# **Appendix F**

## **AUTHORITY CONSULTATION**

**Re: Meeting – GPT Site – Mamre Road Precinct**

**Re: Lot 59 DP 259135, Mamre Road, Kemps Creek, NSW**  
**Drainage Considerations for E2 Zone Realignment**

PROPOSED E2 REALIGNMENT PLAN  
SCALE 1:1000

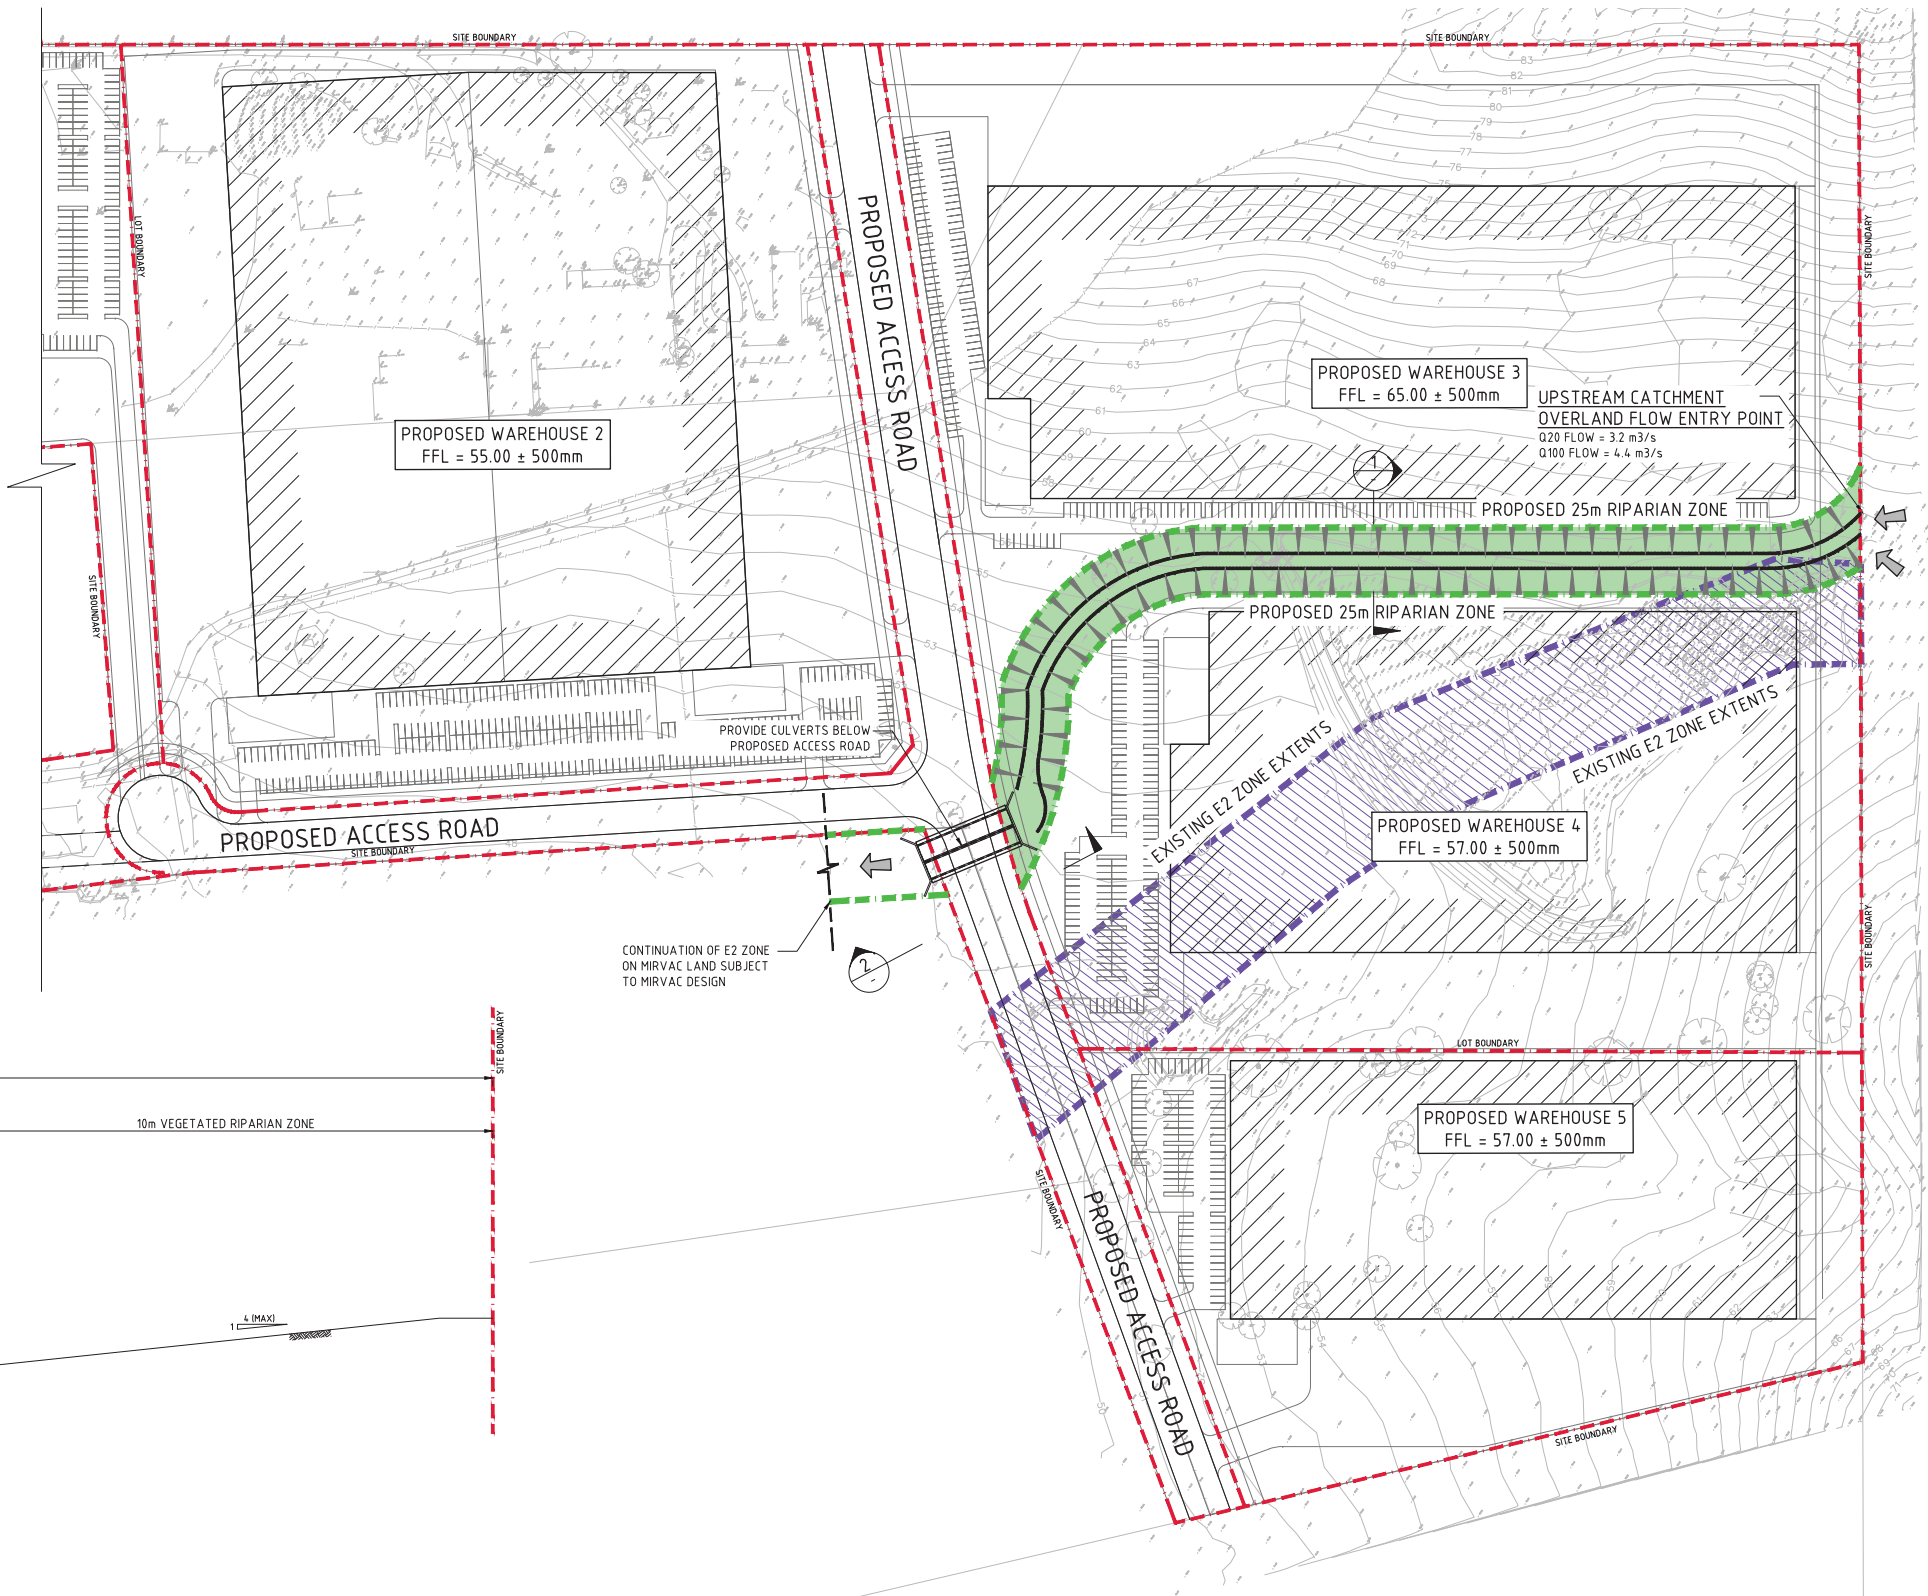
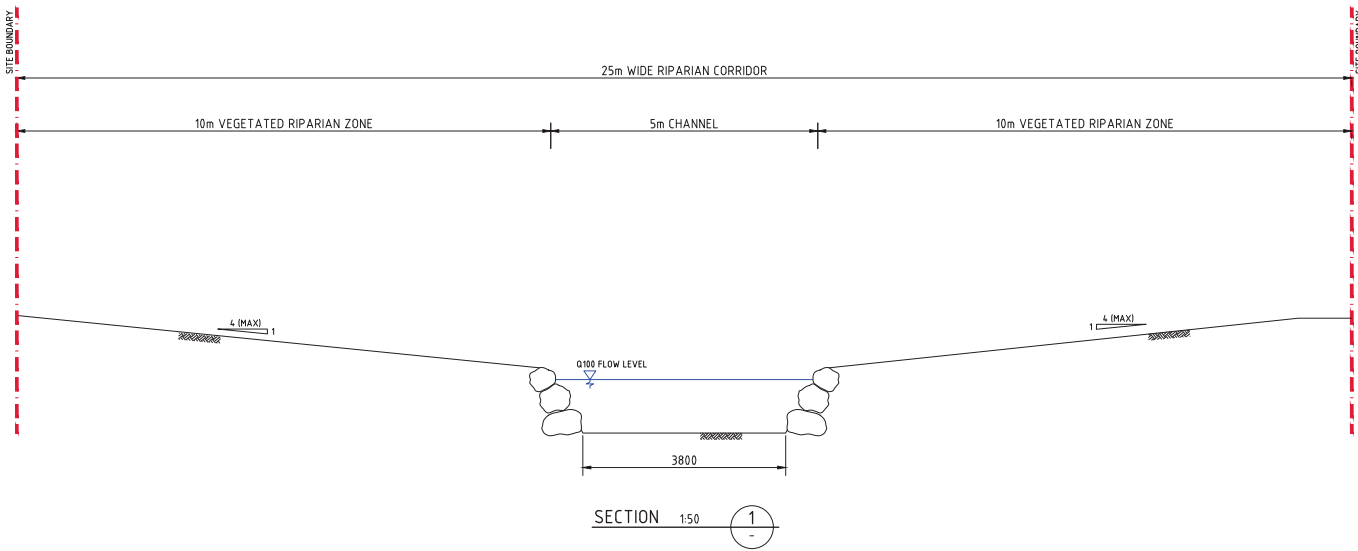
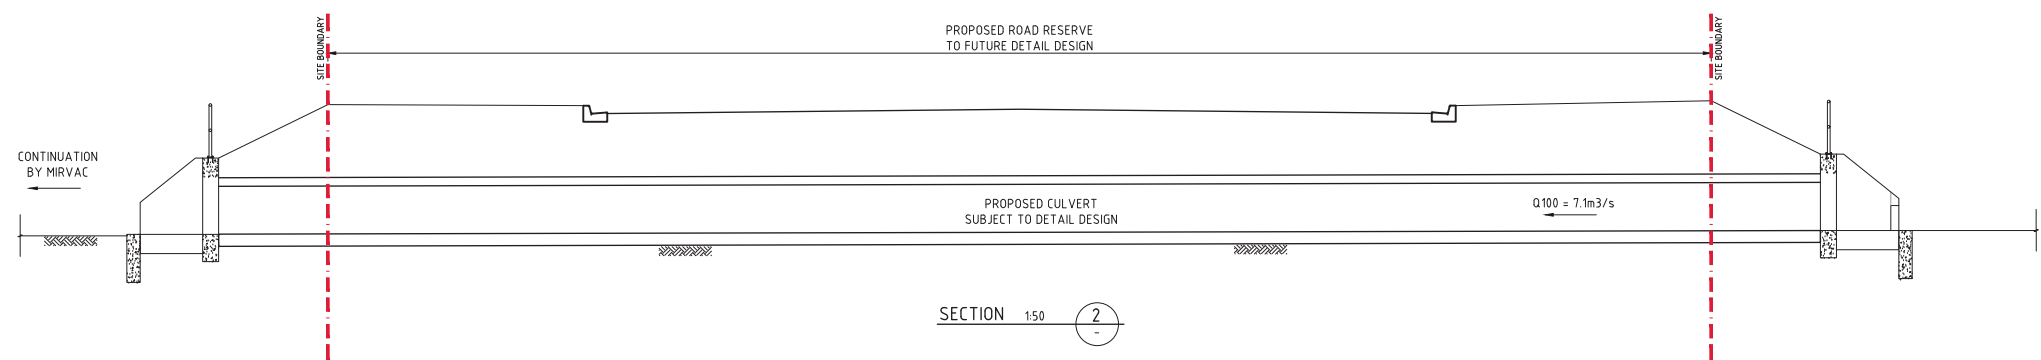
- NRAR is in general agreement that the proposed reconstructed watercourse within the GTP site can be realigned. Realignment should not include 90 degree sharp meanders. The alignment should mimic natural stream design.

- Realignment is to minimise impact to remnant vegetation areas upstream of the site.
- NRAR requires details of the realignment on up and down stream sites prior to signing off on final realignment.

- NRAR does not support the reduction in the corridor width from 40m to 20m in the upstream reach within the GPT site. It is noted that the reduction of stream ordering due to the removal of upstream 1<sup>st</sup> order watercourses is contrary to the requirements of the NRAR CAA Guidelines for riparian corridors.

As noted it is proposed by The GPT Group to realign the E2 Zone currently shown by DPIE and watercourse as part of the proposed development. With reference to drawing **Co13874.06-SK04** in **Enclosure 2**, flows from the contributing catchment are proposed to be conveyed within a new engineered, though naturalised, channel. The channel concept and a typical cross section is shown on the drawing. The section is noted to contain a 5m wide channel, with a 3.8m base and natural rock line channel banks. A 10m core riparian zone (CRZ) is proposed in accordance the requirements for a first order stream, as set out in the NRAR guidelines for works within controlled areas – refer **Enclosure 1**. The 10m CRZ will comprise battered vegetated slope. An overall 25m zone for the E2 Zone corridor and watercourse realignment is proposed.

In relation to conveyance capacity and stormwater management, as noted above, the calculated peak flow in the 1% AEP storm event is 4.4m<sup>3</sup>/s. This peak flow is noted to be able to be conveyed within the proposed cross section at a depth of approximately 0.8m. The advanced concept designs to be included in the Development Approval documents will

ensure that the channel is maintained with a naturalised feel, per the recommendations of NRAR. Consideration to a meandering low flow conveyance area will be integrated into the channel, and where changes in direction occur (including adjacent to the proposed road) consideration to additional scour protection via natural rock rip-rap and other suitable scour protection means will be made. Consideration to bio-diversity corridor (refer Cumberland Ecology letter) can be achieved in the 10m zone either side of the flow conveyance channel.

Overall, we conclude that the existing watercourse can be realigned within the proposed 25m corridor. Further that the proposed 25m corridor meets the requirements of NRAR for a first order stream and that the 1% AEP flow of 4.4m<sup>3</sup>/s can be readily accommodated within the proposed naturalised channel.

**Figure 1. Proposed Channel Curves and Radius.**

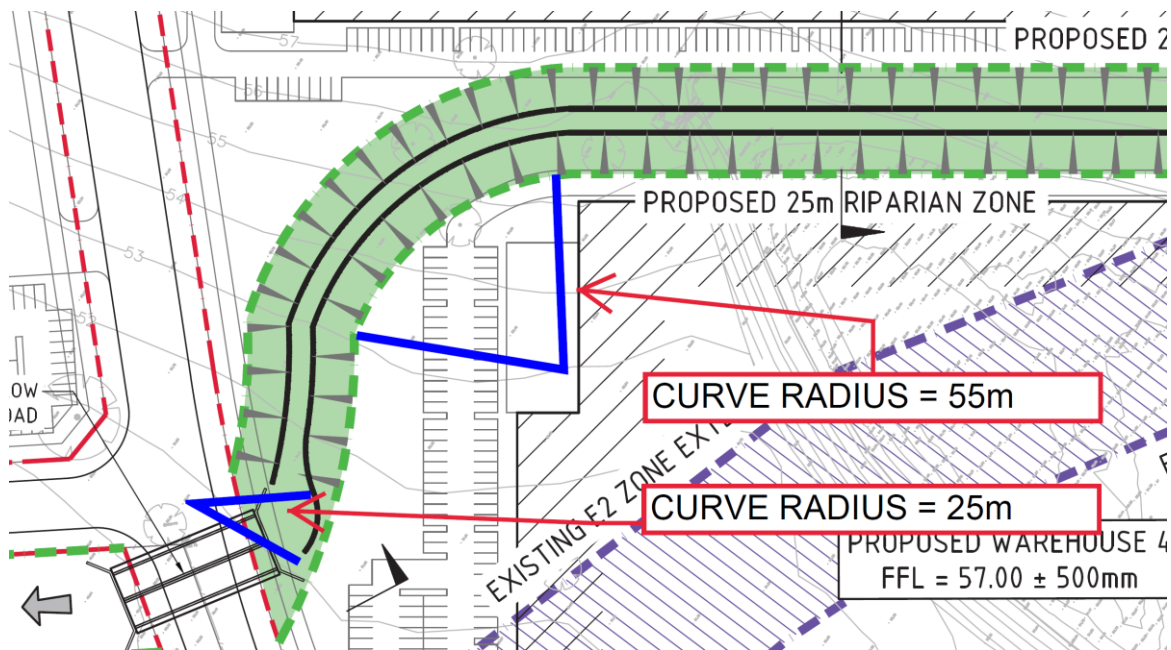
We understand the geometry of the watercourse has been questioned by NRAR, specifically the changes in direction of the channel.

A 90-degree change in direction, with a prolonged curved radius, is proposed through the lower portion of the channel and at the entry to the culvert. The curved radius is noted to be approximately 55m in length, and the corresponding radius at the entry to the culvert is 25m – refer **Figure 1**.

Review of recommended practice for naturalised creeks has been made using accepted industry methods for naturalised creek design, included in documents such as the *Queensland Urban Drainage Manual 2013*, and Brisbane City Councils *Natural Channel Design Guidelines 2003*. Within these documents recommended minimum radius of bends are recommended, based on the bankfull width of the watercourse. The recommended minimum radius for a constructed bend is 3 times the bankfull width.

For this project, noting the bankfull width of 5m, the minimum acceptable design radius of curvature as such is 15m. As shown in **Figure 1**, the proposed minimum radius is 25m, and where the larger change in direction is proposed (55m radius) the radius is noted to be 3.6 times greater than the minimum recommended curve radius.

The proposed geometry allows for generous curvature at changes in direction that are considered acceptable based on the noted literature, accepted industry and naturalised channel design practices. As noted in this letter, additional design elements would be included in the design as design progresses and in principal support of the concept has been agreed with NRAR.
